ROPED HYDRAULIC LULA ELEVATOR LAYOUT DRAWING SUBMITTAL

PROJECT NAME: HYATT BUILDING
LOCATION: S. MAIN ST.
FINDLAY, OH 45840

Table with 2 rows: JOB NAME: HYATT BUILDING; DRAWING NUMBER: AMER-18261

HOISTWAY PLAN (RR-1-1400P)

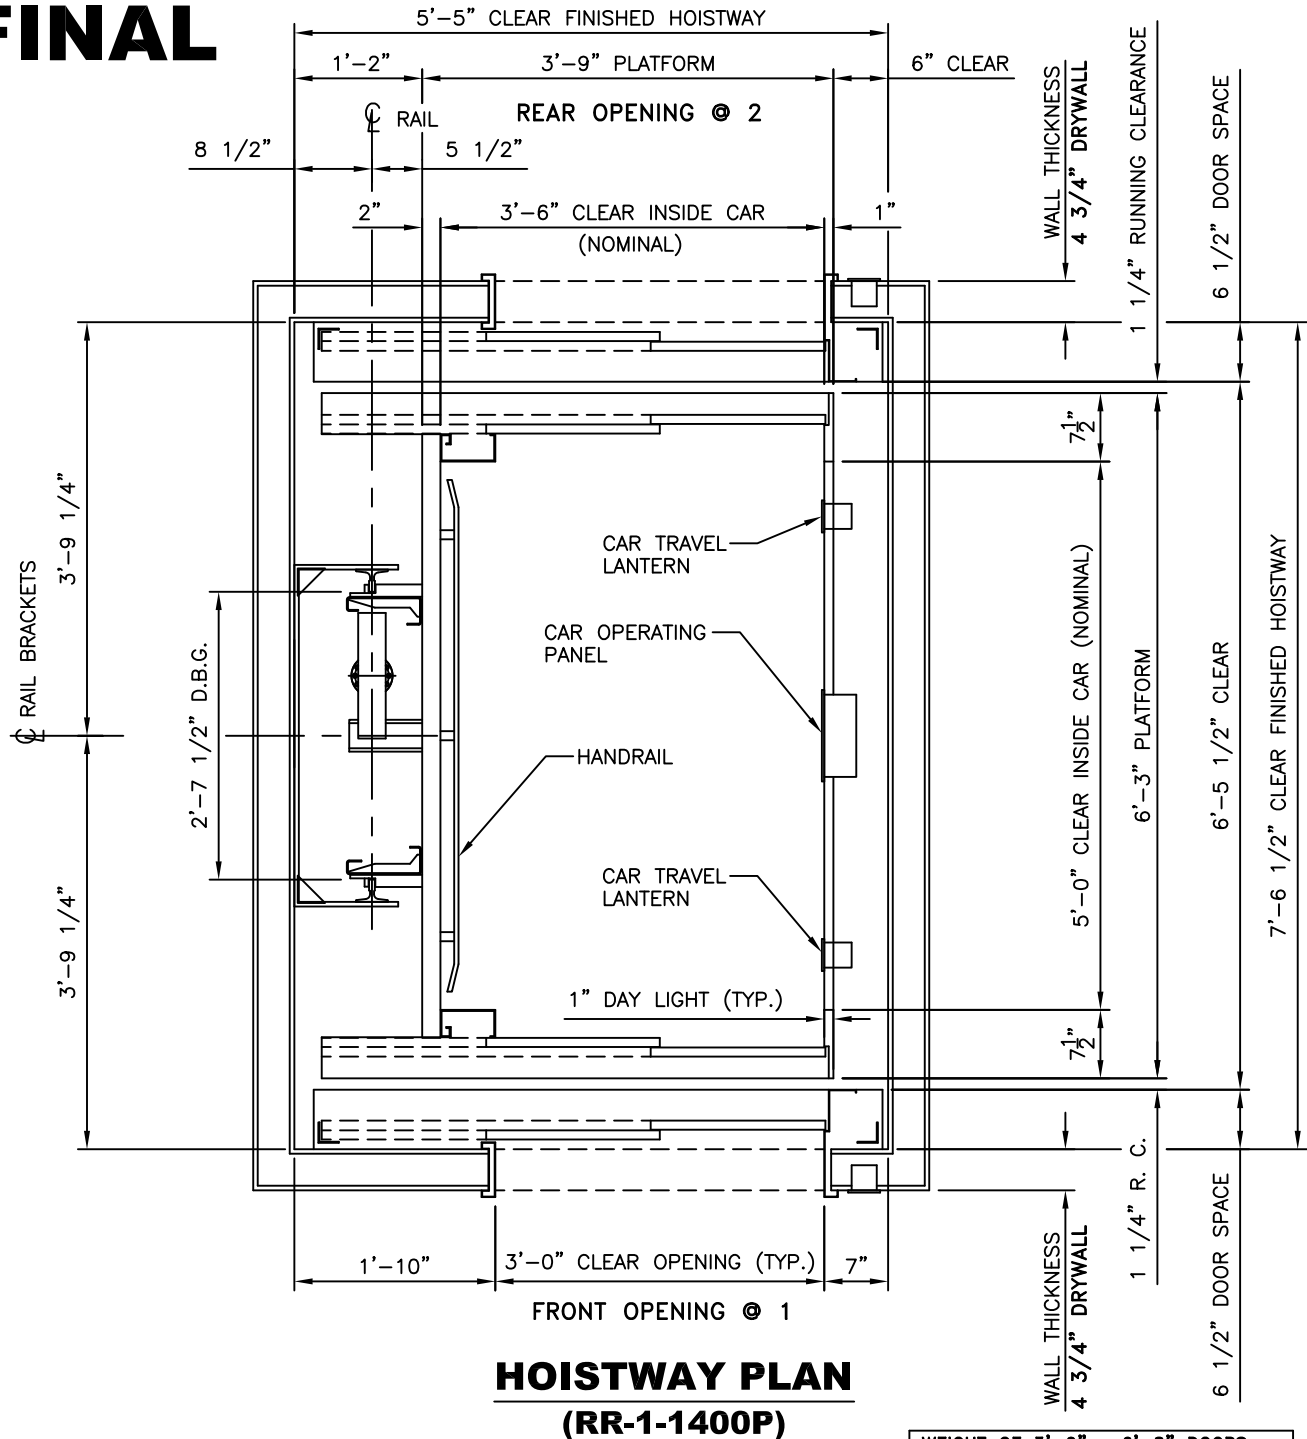
Table with 3 columns: REV., DATE, DESCRIPTION. Row 1: 1, 3-22-18, PIT DEPTH WAS 1'-2", MAIN POWER WAS 220V, ADDED CAB WALL COLOR. FINAL.
